**TECHNICAL INSTRUCTIONS  
FOR  
SAFETY RECALL 20TA06  
POTENTIAL VEHICLE STALL WHILE DRIVING  
CERTAIN 2020 MODEL YEAR HIGHLANDER**

### **UPDATE 3/24/2020**

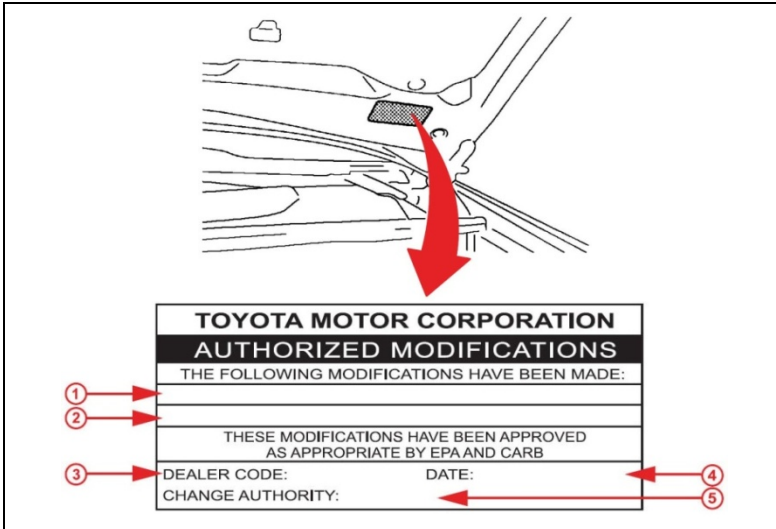
The ignition needs to be turned to the "OFF" Position within 3 seconds of the screen below displaying to prevent DTC U0155 from occurring

- **Added caution to turn the ignition to the “OFF” position within 3 seconds of the reflash completing to prevent DTC U0155 from occurring**
